# Airworthiness Directive Schedule

### Hawker Beechcraft 33, 35 and 36 Series (Bonanza and Debonair)

26 April 2018

Figure 1 - Forward Elevator Control Cable - Adapted from the Beechcraft IPC.

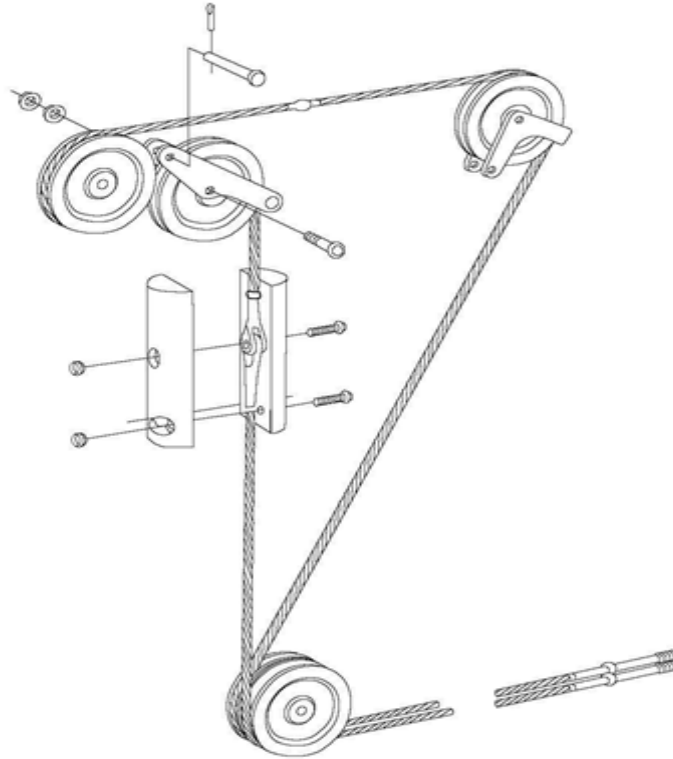
**Applicability:** Model F33A, 35-C33A, V35, V35B and A36 aircraft, all S/N fitted with a forward elevator control cable configuration per figure 1 of this AD.

1. Replace the forward elevator cable assembly, or  
Inspect the forward elevator control cable assembly for wear, broken wires and corrosion. If any defects are found, replace the forward elevator control cable assembly before further flight.
2. Cable assemblies or parts removed from service per the requirements of this AD may not be installed on any aircraft.
